SERVICE BULLETIN

B-036 October 23, 2000

SAFETY RECALL CODE 0822 - BLAST REAR SPROCKET

Figure 3. Rear Sprocket Assembly

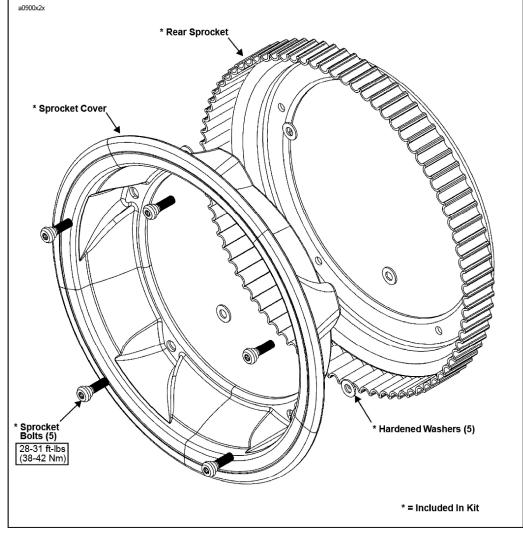
This condition will be remedied by replacing the rear sprocket, sprocket cover, drive belt and installing the recalibrator on all potentially affected vehicles.

The Blast Rear Sprocket Recall Kit (Part No. 94019Y) consists of:

- 80 Tooth Rear Sprocket
- 139 Tooth Drive Belt
- Sprocket Cover
- (5) Hardened Washers
- (5) Bolts
- Speedometer Recalibrator
- (2) Cable Ties

Use only new P/N BA0511.2Z hardened washers between sprocket cover and sprocket. Failure to use hardened washers could cause sprocket to fail. Drive sprocket failure could lead to loss of control of vehicle which could result in death or serious injury.

- Place sprocket on rear wheel while rear wheel assembly is lying flat on bench.
- 23. See Figure 3. Place new hardened washers on sprocket.
- 24. Install new sprocket cover over washers and sprocket.

- 25. Install five new sprocket bolts to sprocket, sprocket cover and rear wheel. Make sure washers are positively retained by mounting bolts. Tighten sprocket bolts to 28-31 ft-lbs (38-42 Nm).
